City of Washington, Illinois
Farm Creek Trunk Sewer
3rd Party Alignment Analysis
HCE Job# 21911

DATE: June 22, 2023
TO: City of Washington, IL
FROM: Howard Hamilton, PE, CFM, CPESC
SUBJECT: Alternative Analysis, Draft Concerns/Updates and
Smoke Test Discussion
HCE # 21911

CITY OF WASHINGTON
FARM CREEK TRUNK SEWER 3RD PARTY ALIGNMENT ANALYSIS
ALIGNMENT E-3 COMPARISON

Existing Farm Creek Trunk Sewer Bottleneck #1

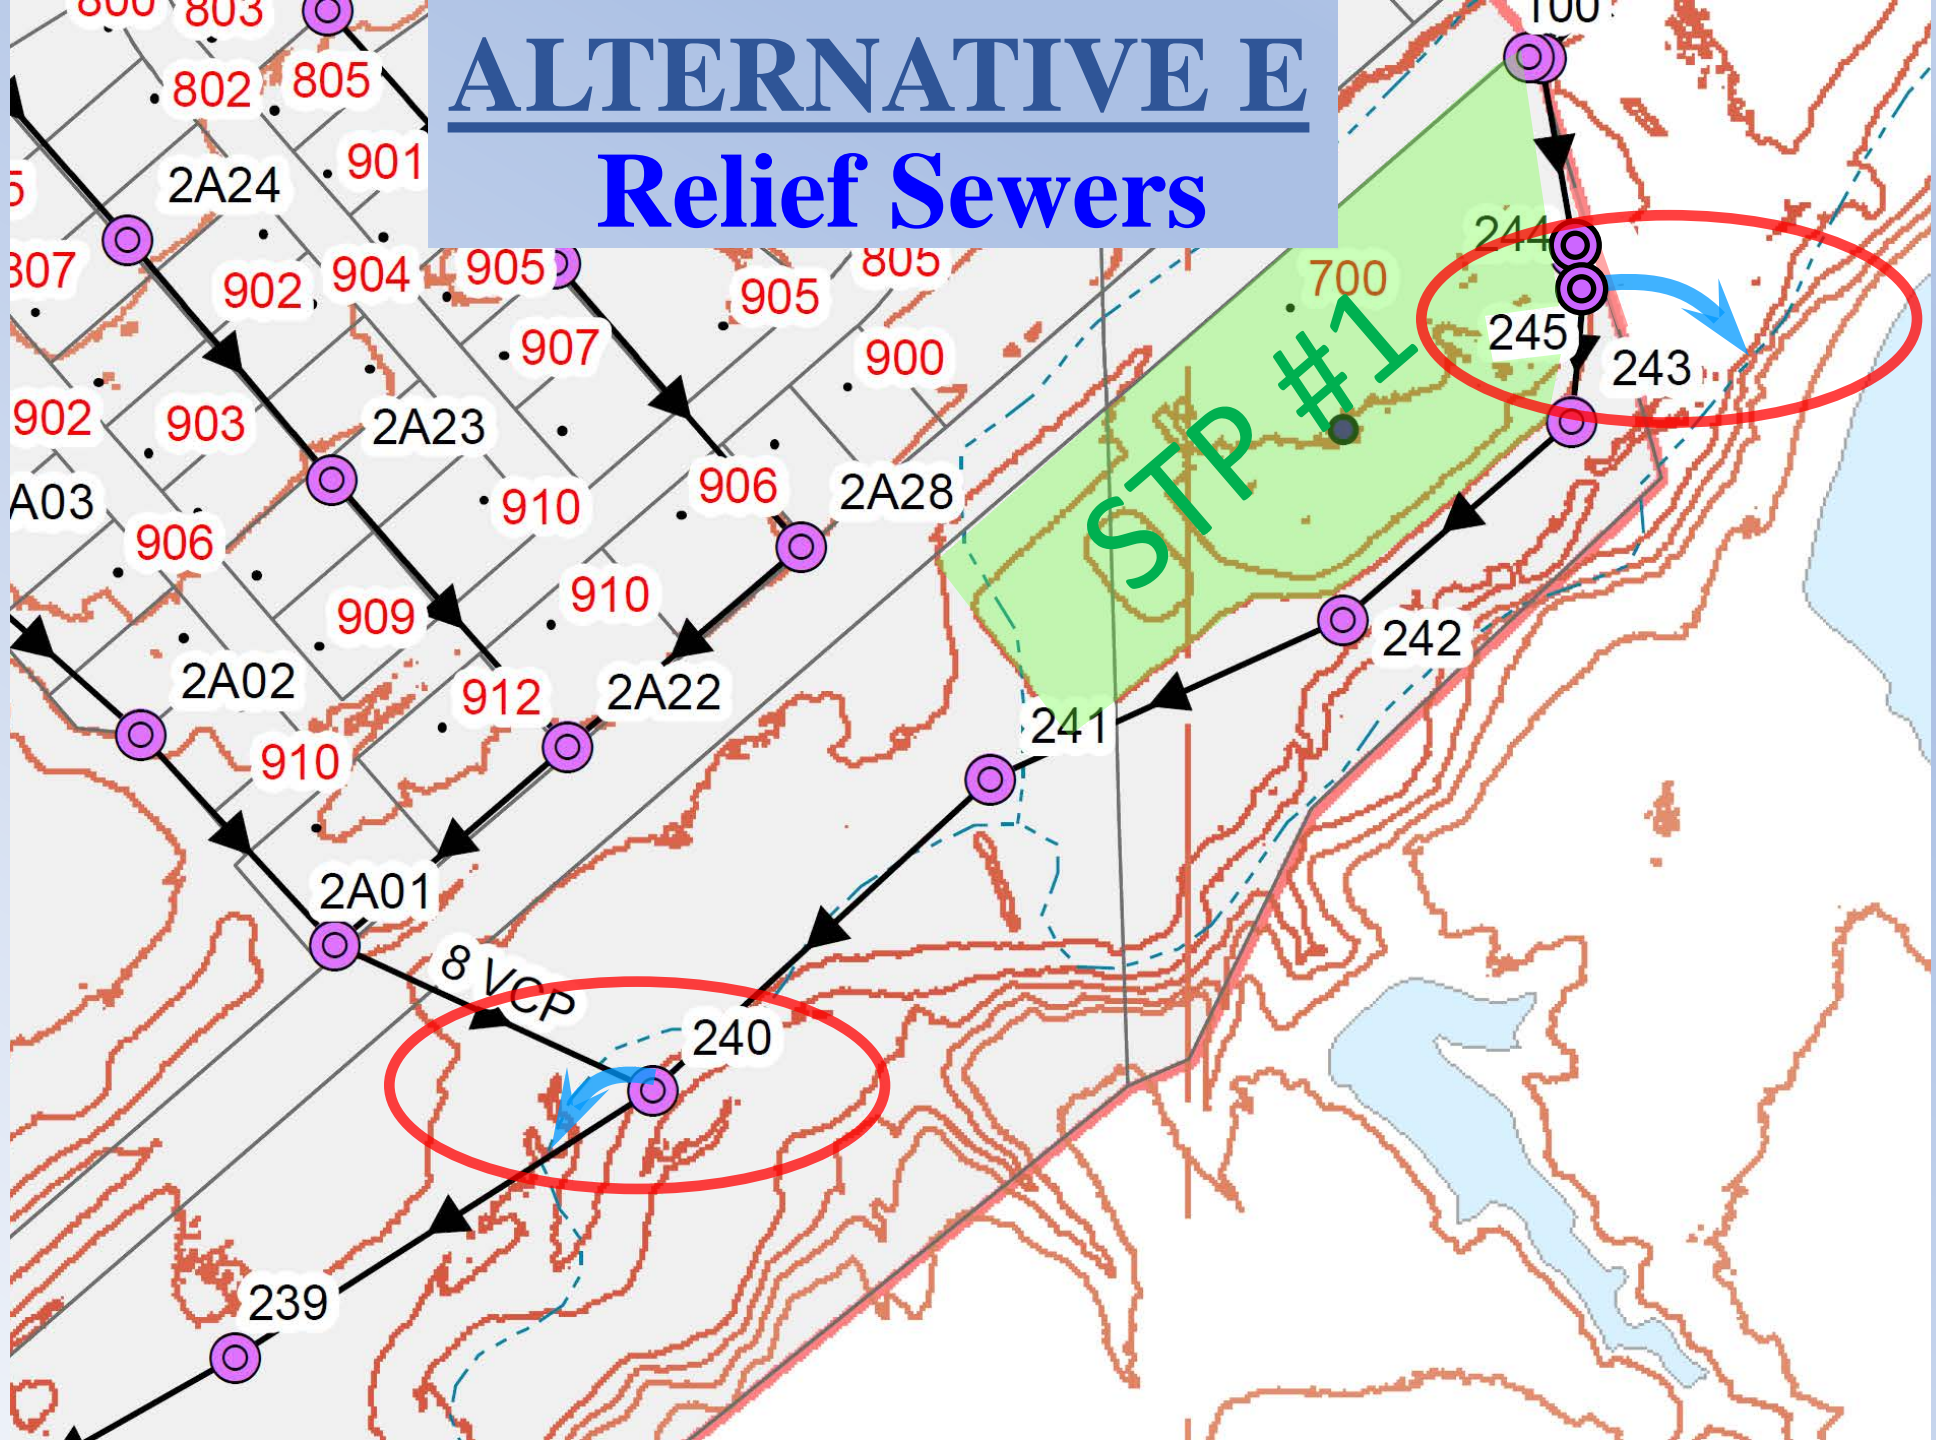
3. The length of sewer between Manholes 238 and 245 has a capacity of only 5,882 gallons per minute (gpm) which is enough for peak flow from 35,145 PE.

However, the recorded flow on August 30, 2016 was nearly double that amount at 11,671 gpm.

This causes Manholes 245 and 240 to overflow.

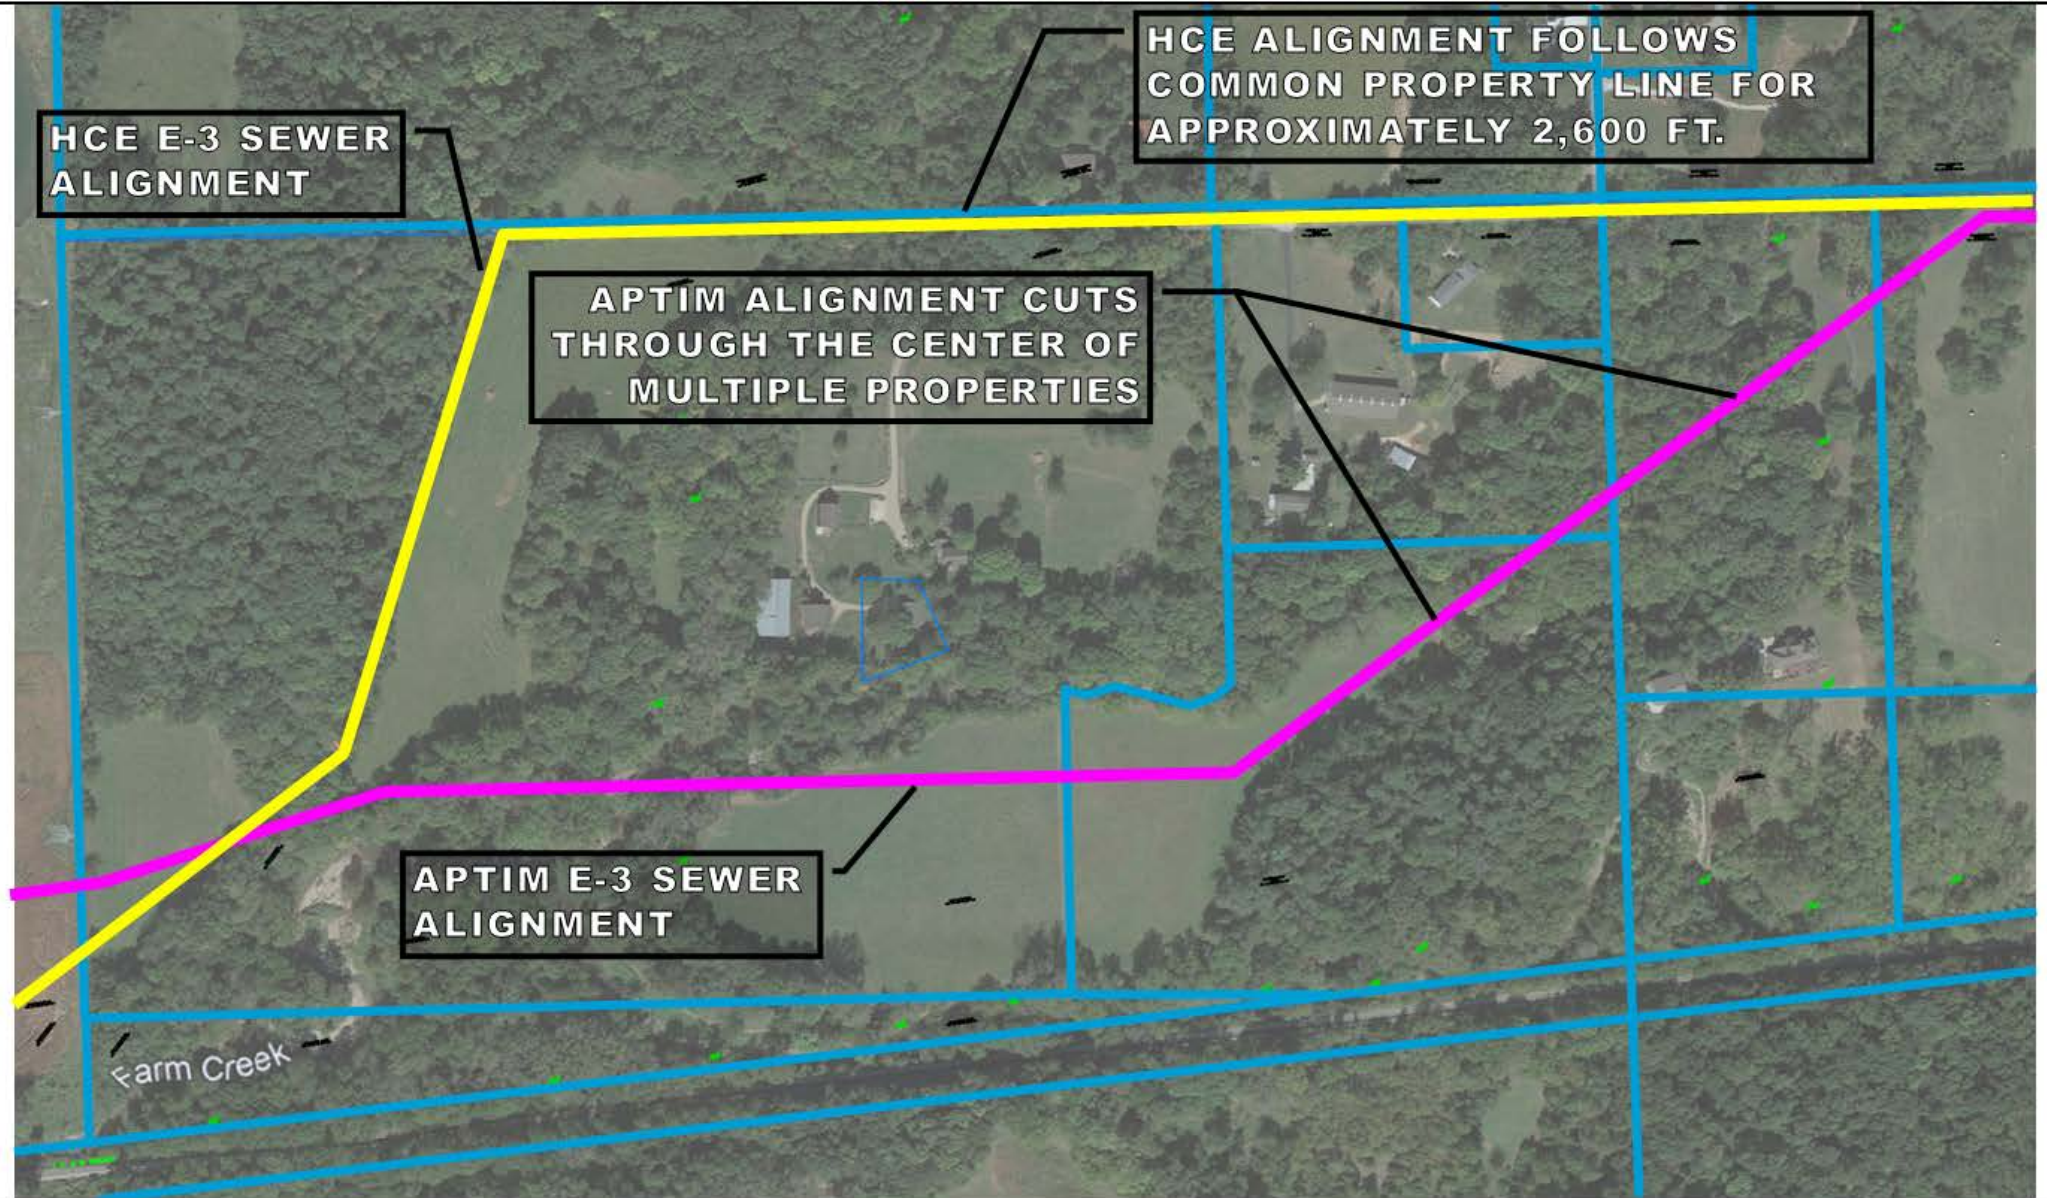
2. Explain revisions to Alignment E-3 from the original location proposed by Aptim/Goat Springs, LLC.

- **Cost**
- **Ease of construction**
- **Acquisition of easements**
- **Impact upon future use of the properties**
- **Ability to extend service to the sewer in the future**
